**From:** [REDACTED]  
**To:** [REDACTED]  
**CC:** [REDACTED]  
**Sent:** 2/23/2021 3:00:52 PM  
**Subject:** RE: O8W-PM 35217268, 35224712, 35224713 - Bucks Creek 1101 Phase 1,2&3 - Pre-Engineering Meeting

# Bucks Creek 1101- PM# 35217268

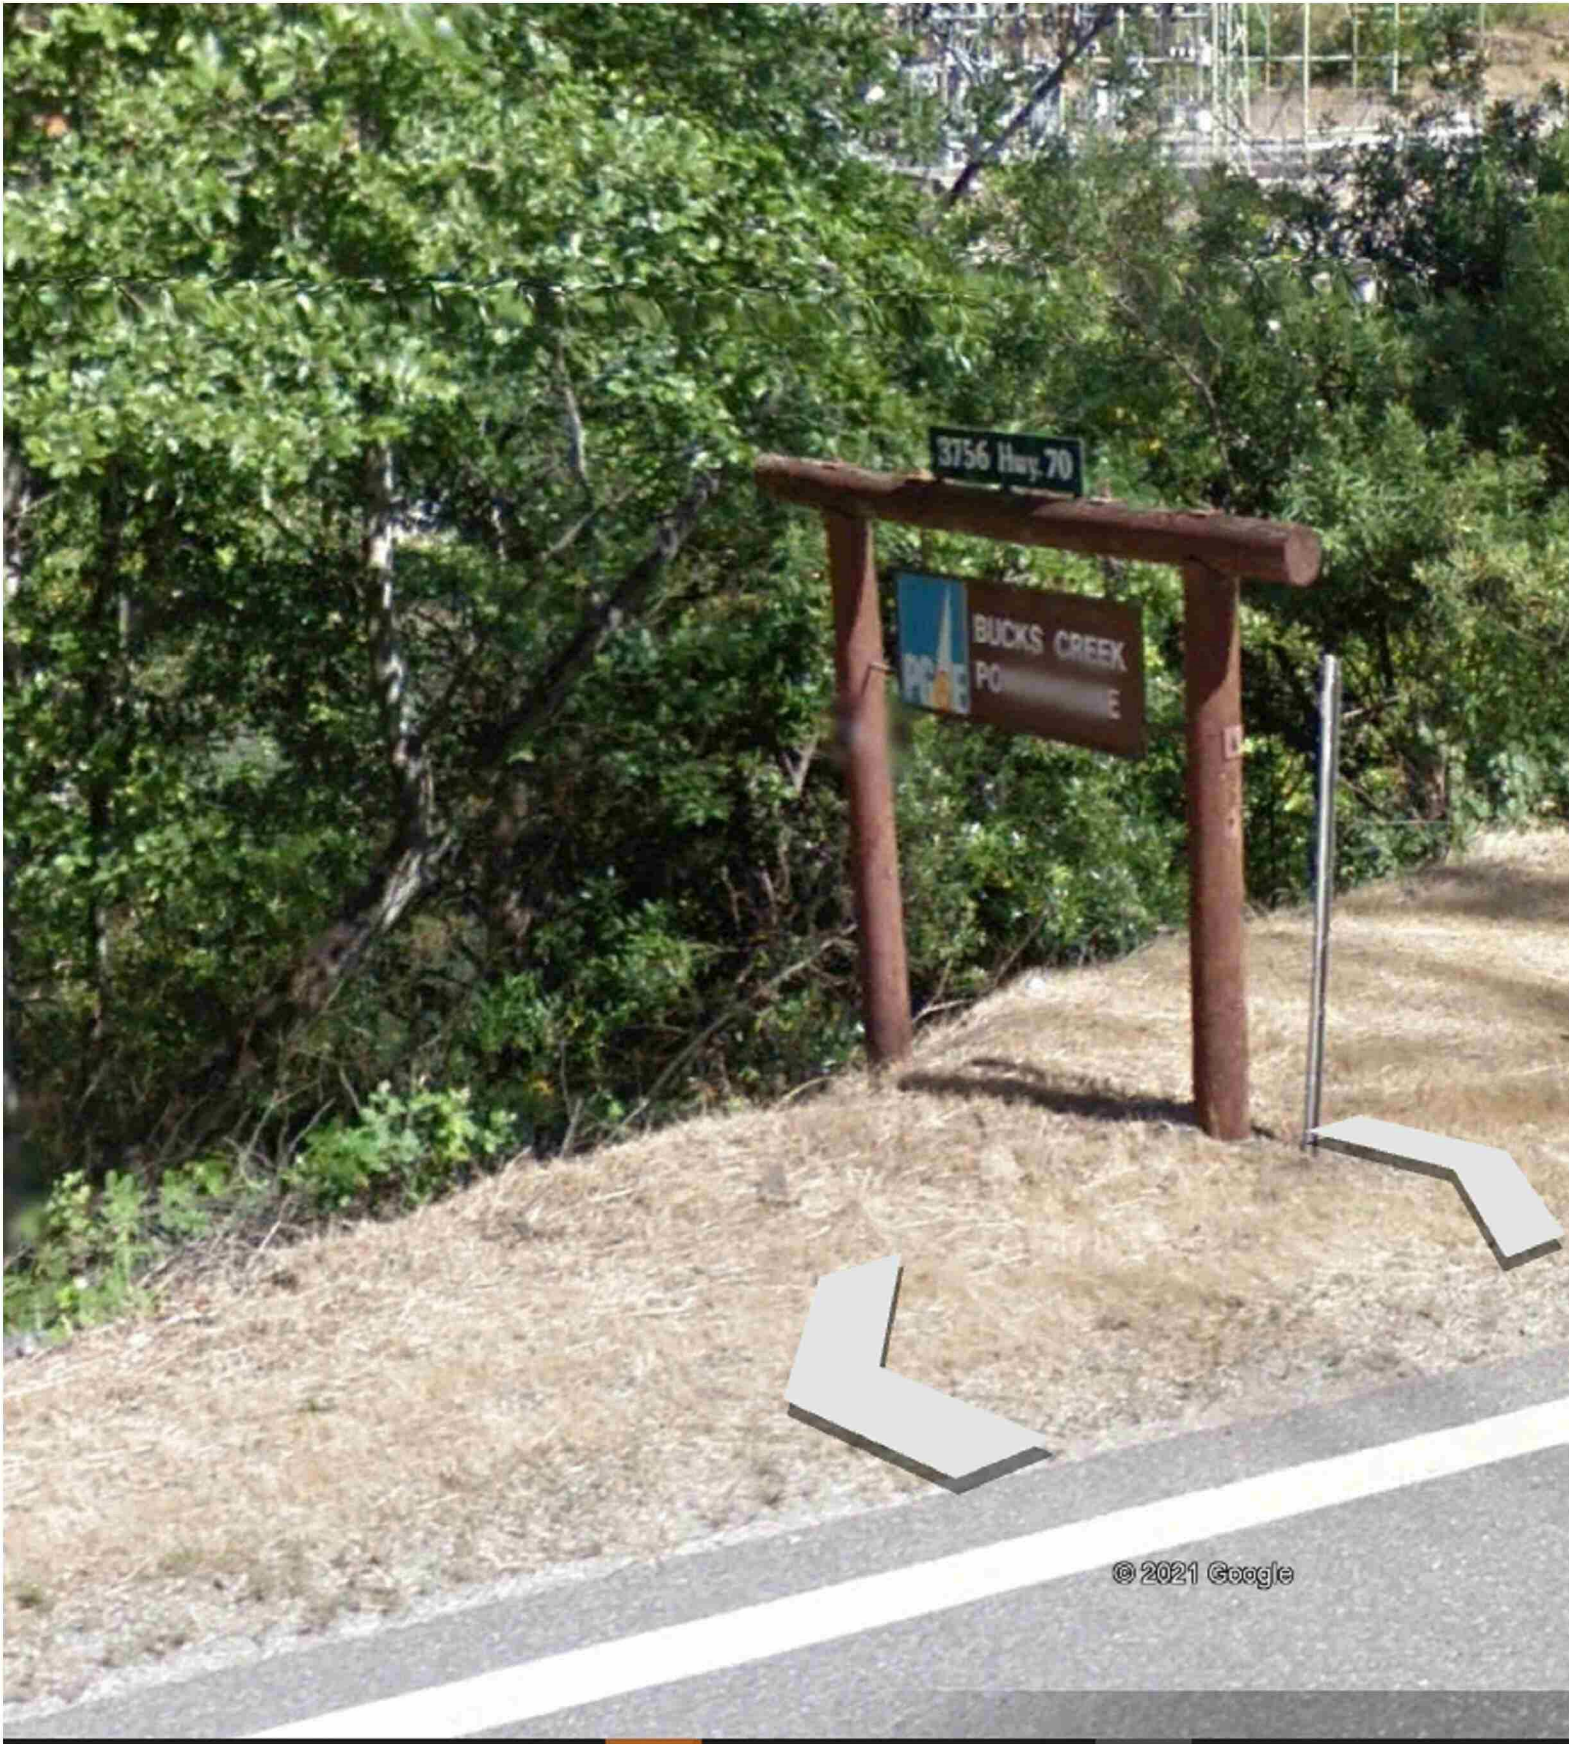
Attached are the 'base-map' limits in a kmz. file. As you will see, we need our base-map to go about ~100' into the tunnel at the south end (see pedestal in picture below....please begin about ~50 beyond this point which is about ~100' beyond the Cresta Dam).

We want to end the base-map at the sign location below which is roughly at MM (Mile Marker) 5.10.
